FORM NC.DE-WB.ZZ-0003-1
EQUIVALENT REPLACEMENT CONFIGURATION CHANGE PACKAGE
COVER SHEET

CHANGE NO.: 4E0 - 3507 PACKAGE NO.: 03

ATTACHMENT NO. 1
TAP Scope of Snubbers

PART 2 - MODIFICATION AND TESTING, SECTION 5.0
 FORM NC.DE-WB.ZZ-0003-7
 MODIFICATION DOCUMENT COVER SHEET

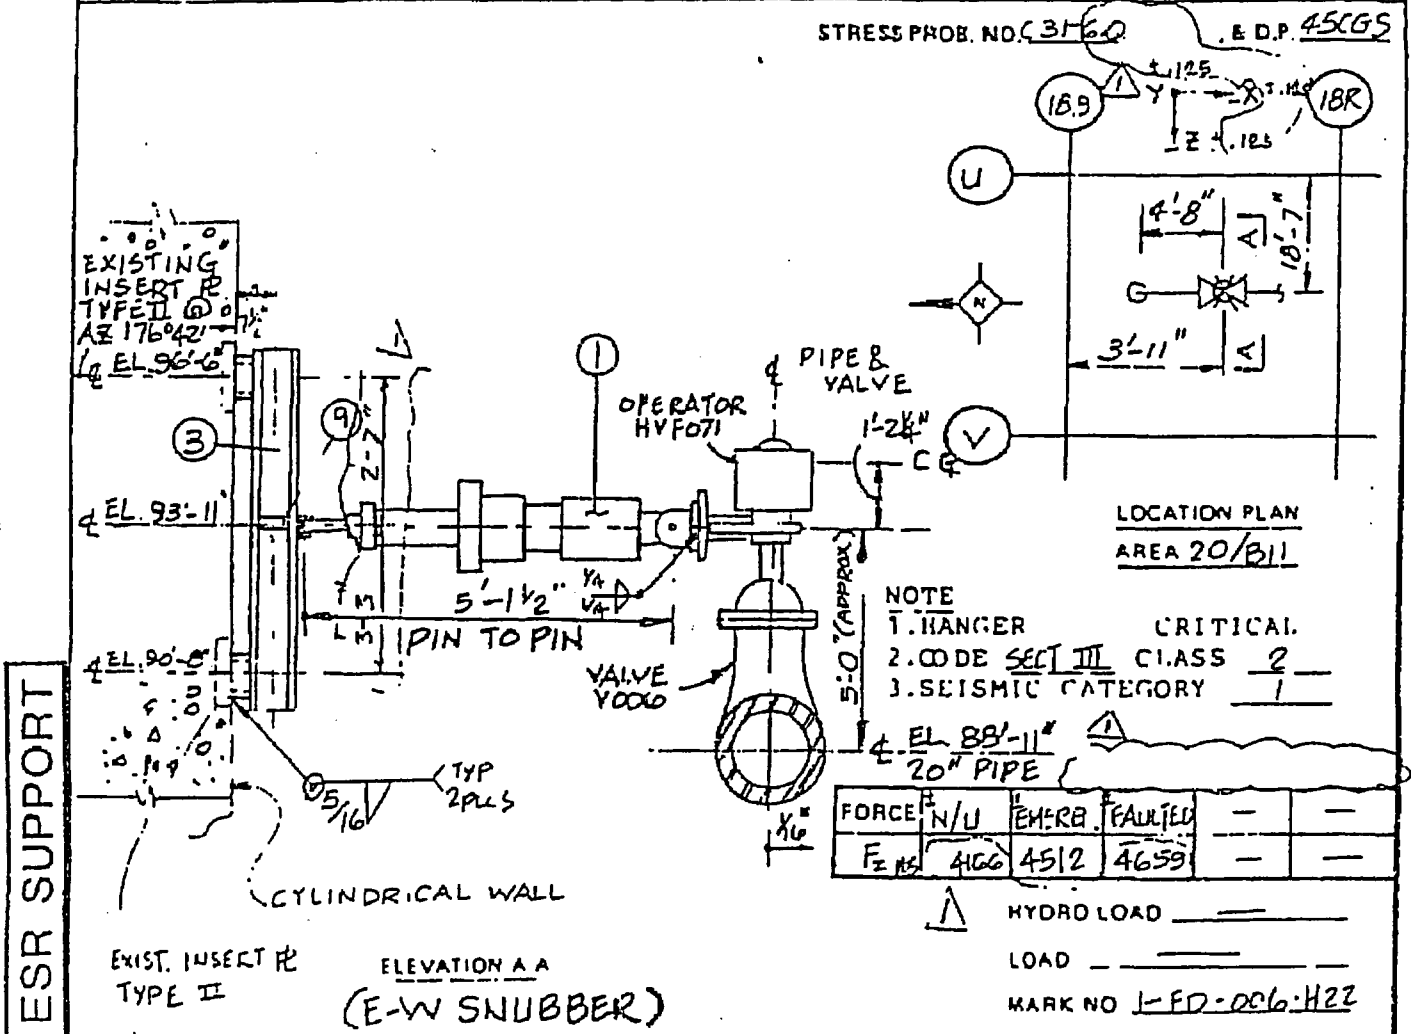
DOCUMENT CHANGED: DWG# 1-P-FD-006-H022 Rev. 1 SHT/VOL NO.: 001
 (PROVIDE TYPE, NUMBER AND REV. THAT CHANGE IS BASED ON)

ACTUAL CHANGE TO BE MADE: Replace existing snubber with LISEGA Hydraulic Snubber as detailed below :

Hanger No.	Existing Snubber	Replaced by New LISEGA Part no.		
		Snubber	Pin	Stud / Pin
1-P-FD-006-H022	PSA0003	305256RE1	30-1003-075	30-1003-075

New Cold Set (CS) (in.)	New Hot Set (HS) (in.)	New Stroke (in.)	Flip (Y/N)	Shroud Removed (Y/N)
N/A	N/A	5.88	N	N

- "Flip" refers to whether or not the new snubber body is to be reversed from its original position.
- "Shroud Removed" refers to whether or not the new snubber housing is to be removed due to interference concerns.
- "Flip" and "Shroud Removed" condition may be changed, from what is specified, as long as it is properly documented (as-built) on this MD.
- Remove any design load information that appears on the drawing.
